# 1984 - 1987 Corvette: Chevrolet Central Office Letter to Corvette Owners: Roof Panel Damage

**Subject:** Roof Panel Damage

**Model and Year:** 1984 - 1987 Corvette

**Date:** April 1988

## INSTALLATION INSTRUCTIONS

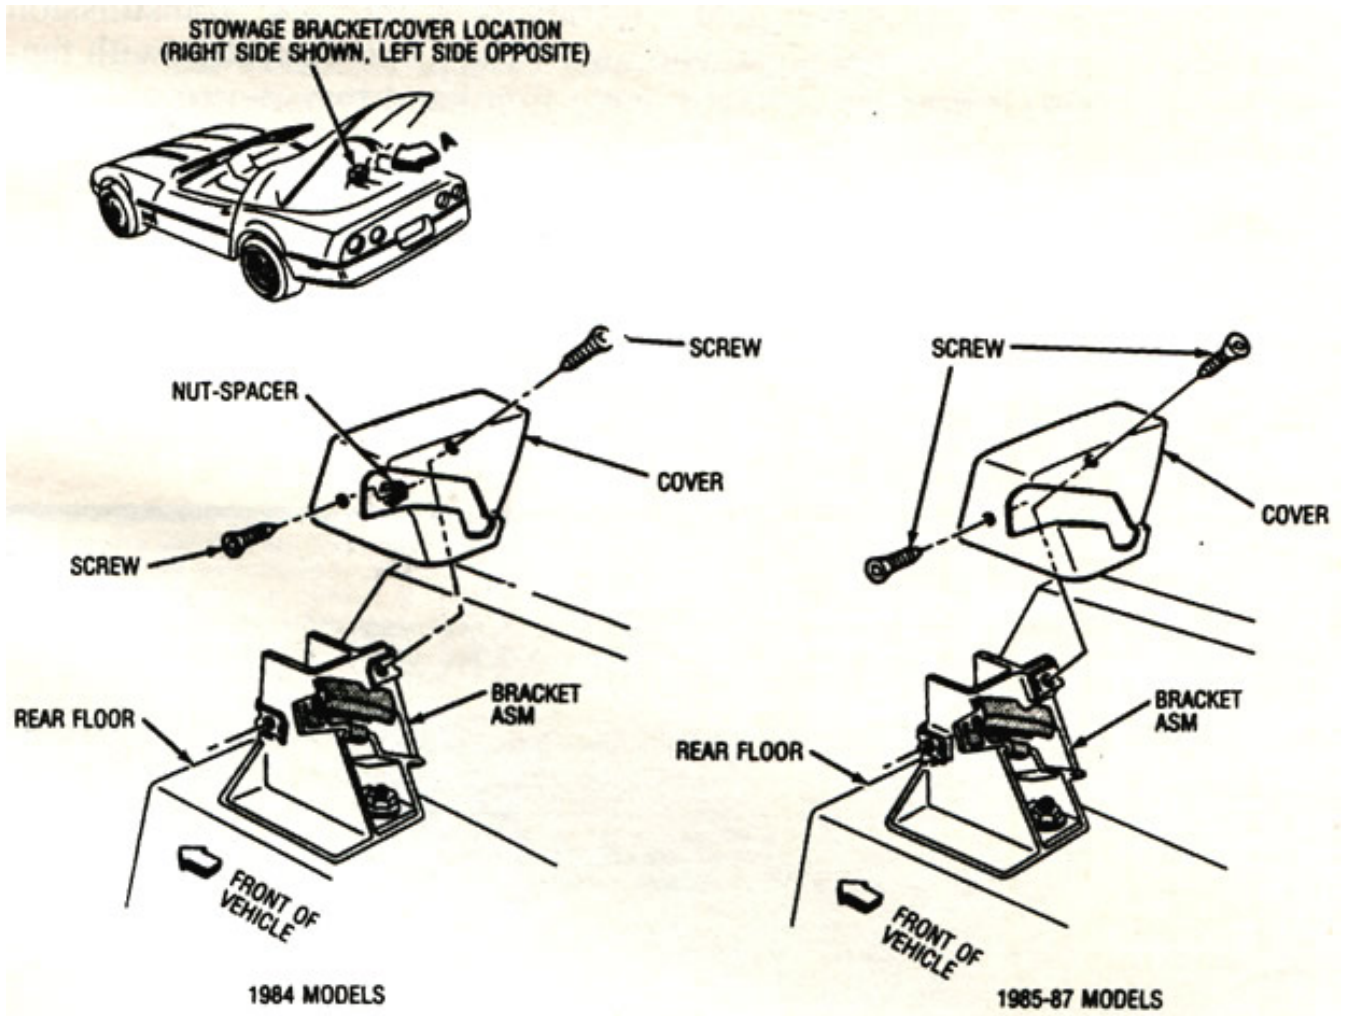
Attempting to lift the front edge of the top excessively while it is seated in the rear compartment stowage brackets, without sliding the top out of the brackets (as could possibly occur when attempting to stow items underneath the top), can lead to the top binding on the bracket covers. Forcing the top beyond this point may damage or crack the rear corners of the top resulting in a repair expense on the part of the owner which is not reimbursable.

Corvettes owners constitute a unique and very special group of Chevrolet customers. With this in mind, and in keeping with our commitment to customer satisfaction, Chevrolet is sending you new removable top stowage bracket covers for installation on your Corvette. These bracket covers allow for additional pivotal movement and will help ensure that no accidental damage occurs to your top. You can easily install the new bracket covers with only a Phillips screw driver by the following the enclosed set of instructions.

1. RAISE HATCH GLASS WINDOW.
2. REMOVE THE TWO SCREWS FROM EACH COVER (SCREWS WILL BE REUSED).
3. REMOVE THE ORIGINAL COVERS.
4. INSTALL THE NEW COVERS AND TIGHTEN THE TWO SCREWS

1. FOLLOW STEPS 1-3 ABOVE
2. INSTALL ONE OF THE SCREWS THROUGH THE INBOARD SCREW HOLE IN ONE OF THE NEW COVERS (SEE ILLUSTRATION).
3. PLACE A NUT-SPACER WITH THE WASHER SIDE TOWARD THE COVER ON THE PREVIOUSLY INSTALLED SCREW.
4. PLACE THE COVER BACK ON THE BRACKET, BEING CAREFUL NOT TO SHARE THE NUT-SPACER OFF THE SCREW. NOTE: THIS NUT-SPACER IS REQUIRED TO SUBSTITUTE FOR THE MOLDED IN FIN-SPACERS WHICH WERE ONLY ON THE 1984 COVERS.
5. RE-INSTALL THE SECOND SCREW AND TIGHTEN BOTH SCREWS, BEING CAREFUL NOT TO TIGHTEN THE SCREWS TO THE POINT OF DEFORMING THE COVER.
